HYUNDAI

Technical Service Bulletin

GROUP BODY ELECTRICAL	NUMBER 26-BE-001H-1
DATE FEBRUARY 2026	MODEL(S) SEE BELOW

SUBJECT: INOPERATIVE HORN ASSEMBLY REPLACEMENT
(WARRANTY EXTENSION Z09)

Before

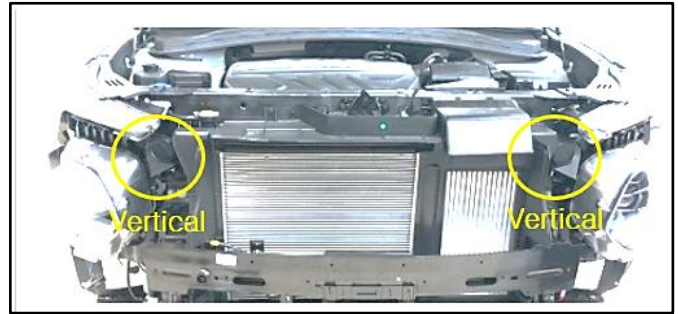
The new horns are intentionally mounted in a vertical position as opposed to the previous horizontal position.

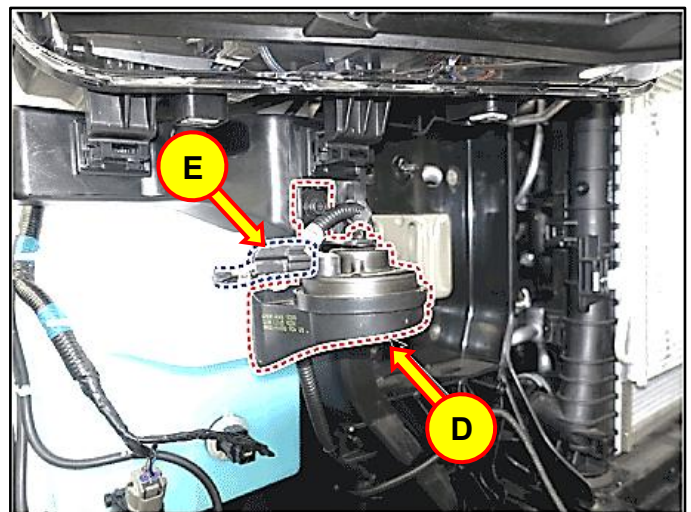
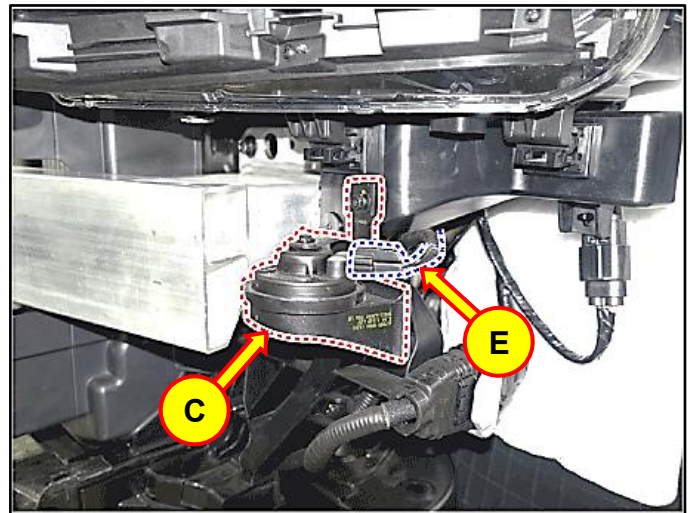
4. Refer to the shop manual to remove both horns (C, D) by disconnecting the horn connector (E) and removing the mounting bolt:

If a horn needs to be replaced, follow the instructions within this TSB to install the latest design.
